BID BULLETIN NO. 5
Bid No. 19-024-06 (Alpha)

This Supplemental/Bid Bulletin is issued to modify, amend or clarify items in the Bidding Documents for the **Runway Strip Grade Correction Including Slope Protection at Maasin Airport (Rebid)**.

CORRECTION IN THE STEEL SHEET PILE DIMENSIONS

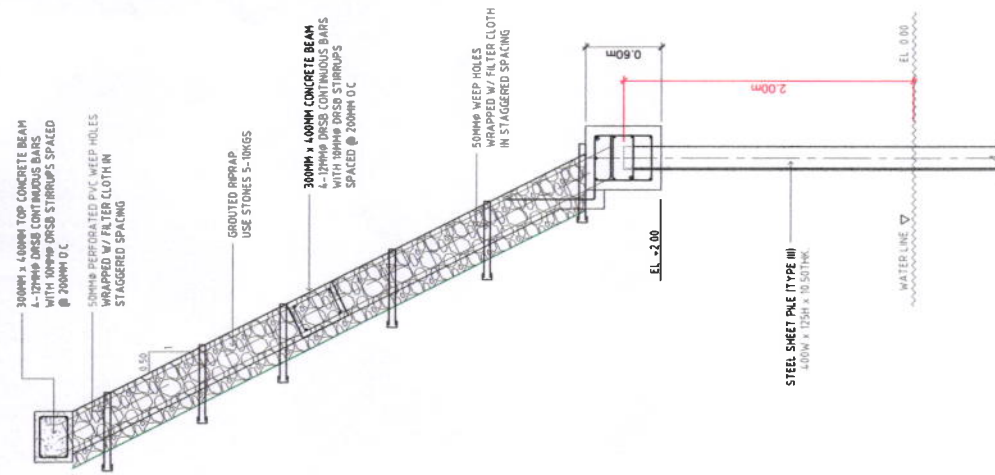
1. Correction in the steel sheet pile dimensions under Sheet No. SP-02 of the approved plans. (see attached layout)
